## PRODUCT CHANGE NOTIFICATION

PCN No.: PCN-202601-021	PCN Doc No.: EC-20260122-PCN-01	Date Issued: 2026/1/22
Part Number or Series: MCSP-S-08-A-SG-T/R	PCN Effective Date: 2026/1/22	
Customer: (If applicable)	P/O No.: (If applicable)	Not affected
Type of Change: ■ Process Change	Last Time Buy Date:	Not affected
Traceability Marking/Date code: No change	Last Time Ship Date:	Not affected
Replacement Part Number: No change	Sample Availability Date:	Not affected

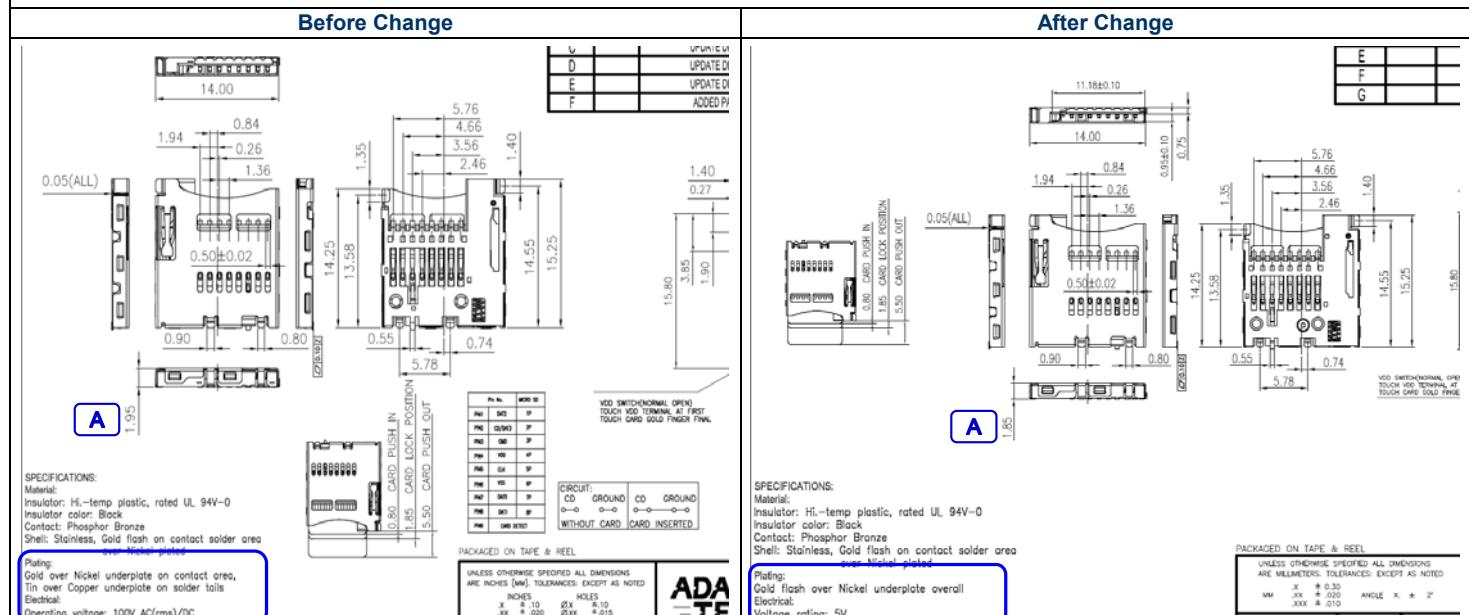
**Change Description:** The solder tail has been changed from tin plating to gold plating;

**Reason for Change:** Process improvement, product optimization;

**Impact of Change:** There are minor changes in appearance and size, but the function remains unaffected;

**Before the change:**

- 1、Size:  
A) 1.95mm;
- 2、Plating:  
Gold over Nickel underplate on contact area,;  
Tin over Copper underplate on solder tails;
- 3、Electrical:  
Operating voltage: 100V AC(rms)/DC;

**After the change:**

- 1、Size:  
A) 1.85mm;
- 2、Plating:  
Gold flash over Nickel underplate overall;
- 3、Electrical:  
Voltage rating: 5V;
